Access Compliance Report

Intersection ID: N/A	Main Street: VILLAGE_WALK_RD	Cross Street: HOUSTON_FIELD_CT	Location: NE
ADA ID: DEFA341A6875	Ramp Type: PerpDiag	Initial Pass/Fail: Fail	Overall Compliance: No
Codes/Mitigation Info/Possible Solution		Field Measurements/Component Compliance

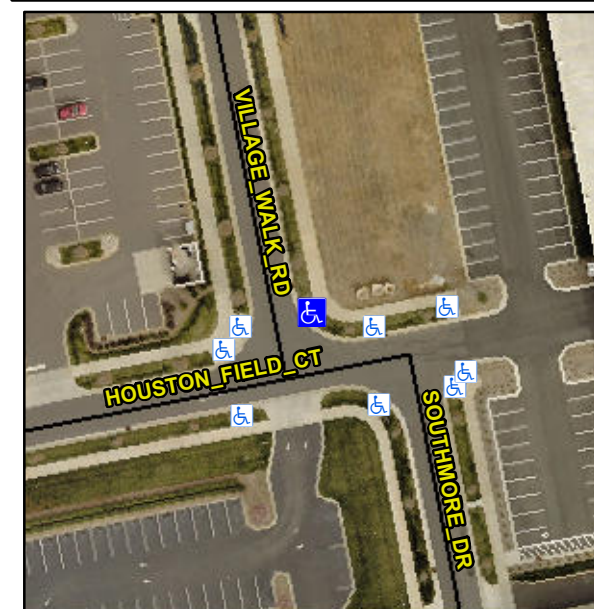
Not Found, R304.2.2, R304.5.3

Compliance	Description	Data	Compliance	Description	Data
N/A	Ramp Length (in)	94.0	No	Ramp Slope (%)	8.8
Yes	Ramp Width (in)	48.0	No	Ramp XSlope (%)	3.2
N/A	Flare Type LT	N/A	N/A	Flare Type RT	N/A
N/A	Flare Slope LT (%)	N/A	N/A	Flare Slope RT (%)	N/A
N/A	Flare Traversable LT?	N/A	N/A	Flare Traversable RT?	N/A
N/A	Landing Length (in)	N/A	N/A	DWS Provided?	N/A
N/A	Landing Width (in)	N/A	N/A	DWS Contrast?	N/A
N/A	Landing Slope (%)	N/A	N/A	DWS Length (in)	N/A
N/A	Landing X Slope (%)	N/A	N/A	DWS Full Width?	N/A
N/A	Landing Curb? (Y/N)	N/A	N/A	DWS Offset (in)	N/A
N/A	Shared Landing?	N/A			
N/A	Gutter Ponding?	N/A	N/A	Gutter Slope (%)	N/A
N/A	Gutter Lip Ht (in)	N/A	N/A	Gutter X Slope (%)	N/A
N/A	Painted X Walk1?	No	N/A	Painted X Walk2?	No
	X Walk 1 Direction	To W		X Walk 2 Direction	To S
N/A	X Walk 1 Width (in)	N/A	N/A	X Walk 2 Width (in)	N/A
	X Walk 1 Slope (%)	4.4		X Walk 2 Slope (%)	0.9
	X Walk 1 X Slope (%)	1.2		X Walk 2 X Slope (%)	3.0

Remove & Replace Curb Ramp With Two New Directional Ramps or Equivalent.
